Technical Bulletin T743

Product: A/V Receiver

Hardware Technical Bulletin: T743-H2005-06

Date: February 28/05 **Subject:** Intermittantly shuts down
Note: Implemented in production from serial number:R44T74306601

Figure 1

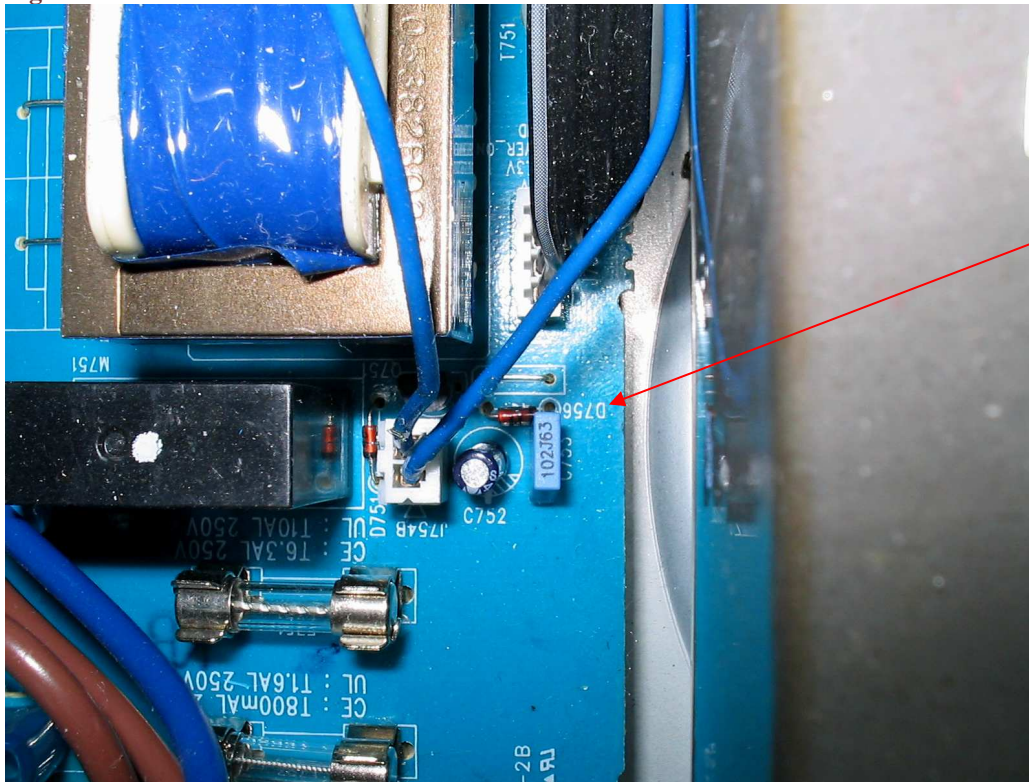
DESCRIPTION: Unit may shut down, shortly after turn on.

REASON: There is a diode on the standby board that maybe operating intermittantly.

SOLUTION: Locate and identify D756 on the standby board. Change only if the diode is a 1N4148. Change from a 1N4148 to a 1N4004 or equivalent. See figure 1 for details.

D756
CHANGE
FROM
1N4148 TO
1N4004
